Subject ▶ Change of Ball Bearing

For Models ▶ HR4000C

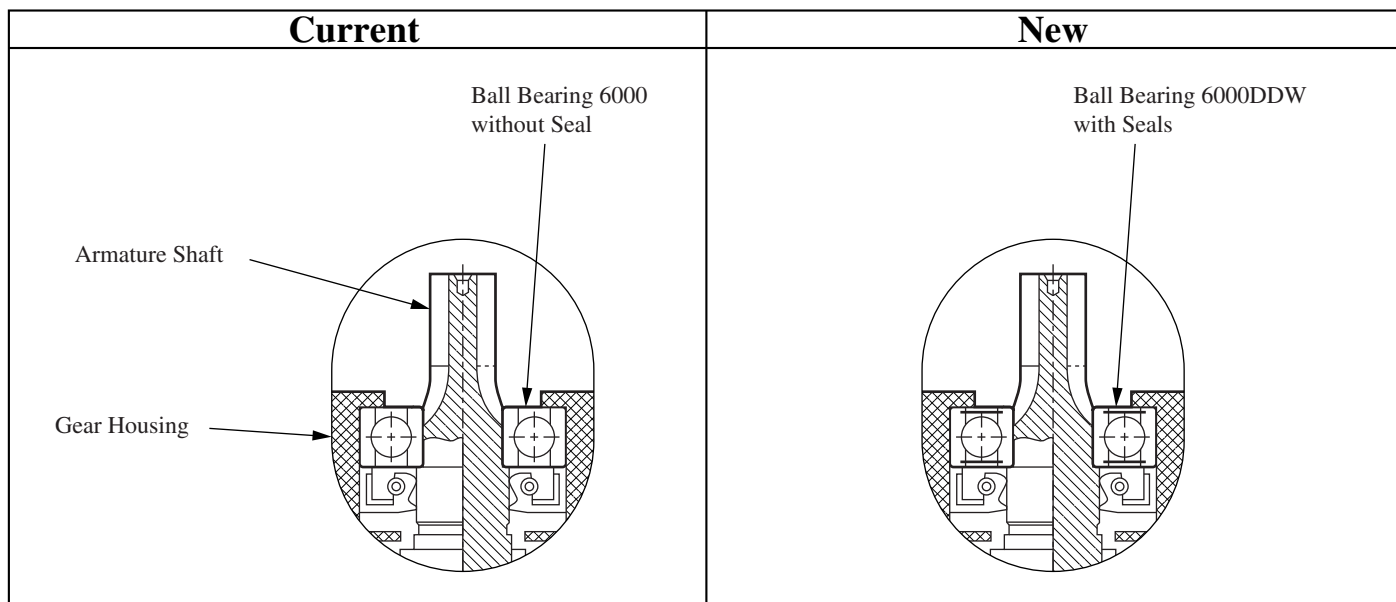
Description ▶ As illustrated below, Ball Bearing 6000 has been changed to Ball Bearing 6000DDW for improvement in endurance of Ball Bearing.

Item No.	Current part		Q'ty	I/C	New part		Q'ty	Note
100	Ball Bearing 6000 211064-1		1	<=	Ball Bearing 6000DDW 211088-7		1

From Feb.,1997, serial No. 12288E
